April 9, 2019

**SUBJECT: NEW VEHICLE DEMONSTRATION / DELIVERY HOLD -  
 Safety Recall 18S45 - Supplement #3**  
 Certain 2015 - 2019 Model Year F-150 and 2017 – 2019 Model Year F-Super Duty  
 Vehicles Equipped with Engine Block Heaters  
 Disable Engine Block Heater Cord

**New! REASON FOR THIS SUPPLEMENT**

FIGURE 1

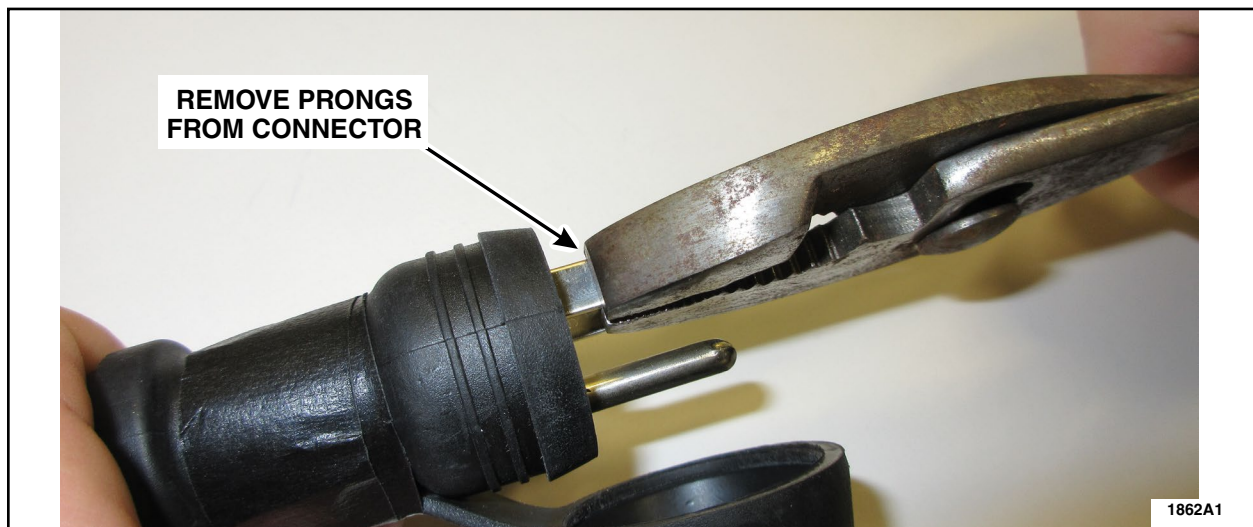
1. Remove the three prongs on the block heater cord using pliers, by bending the prongs back and forth to break the prongs off. See Figure 1.

**FIGURE 2**

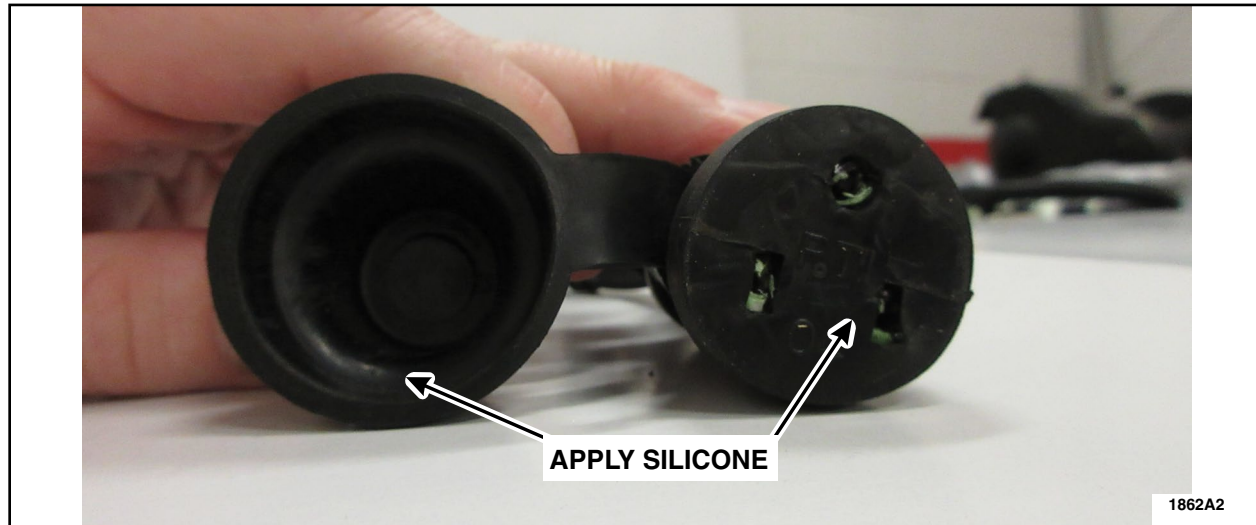
2. Apply Motorcraft silicone sealant TA-32 or equivalent to the cap and plug end. See Figure 2.

**FIGURE 3**

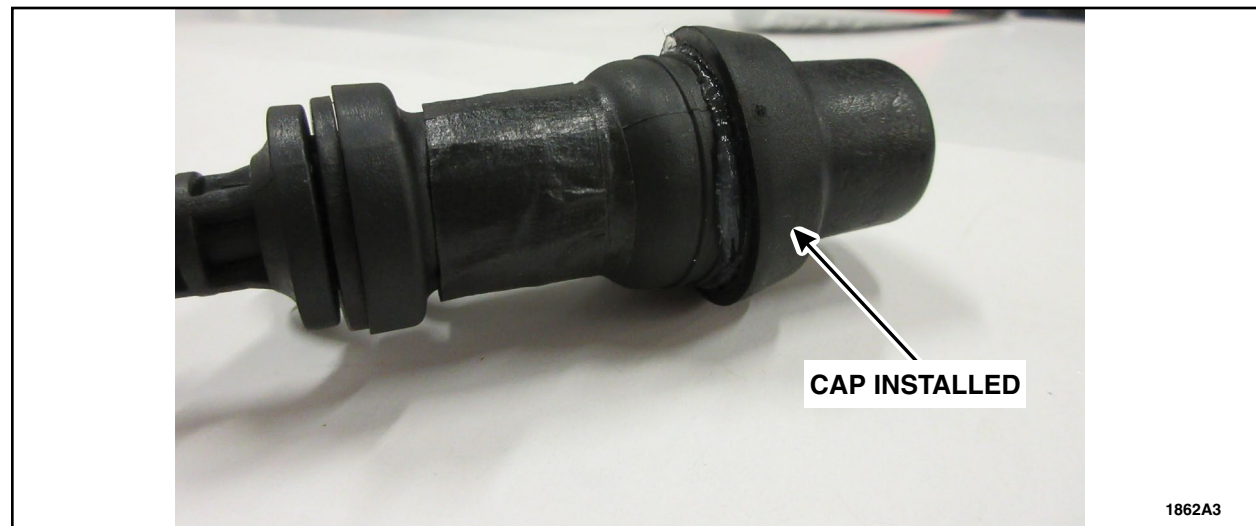
3. Install the cap back onto the block heater cord plug end. See Figure 3.
